# A Review of the Rossland Road Expansion plan

# Road Crossings are made more dangerous

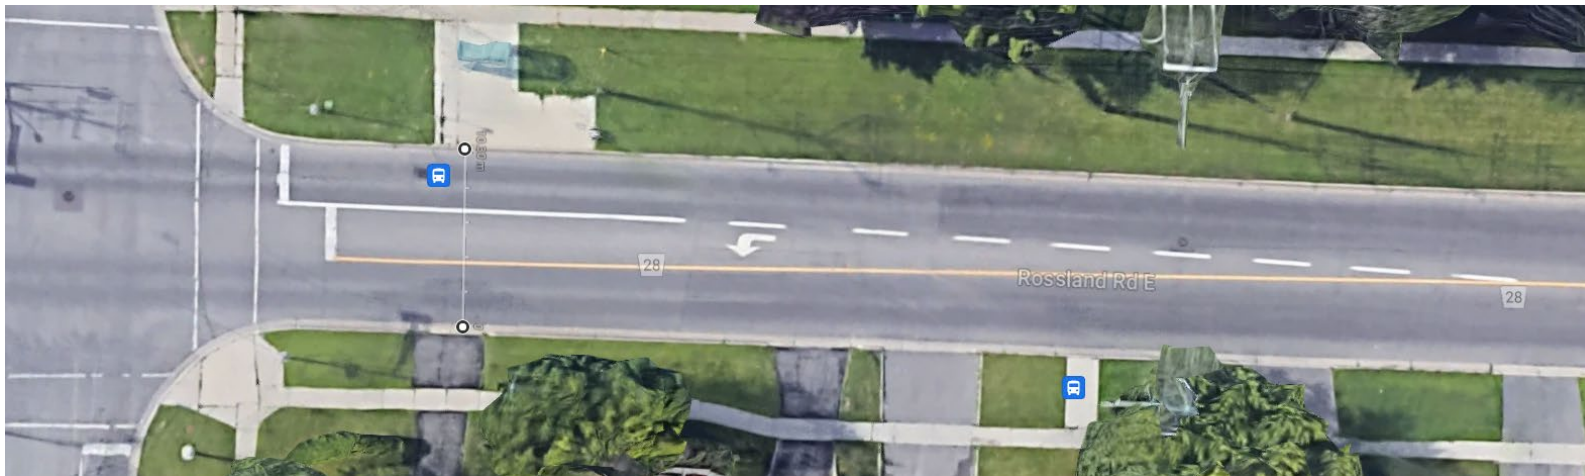
- Bus stops at Rossland and Terrance Dr./Brentwood Ave
- Crossing using the nearest signaled intersection, at Wilson, adds 530m
- Surrounding area is High density Terrace Drive community to the North, and the Brentwood Ave Community to the South
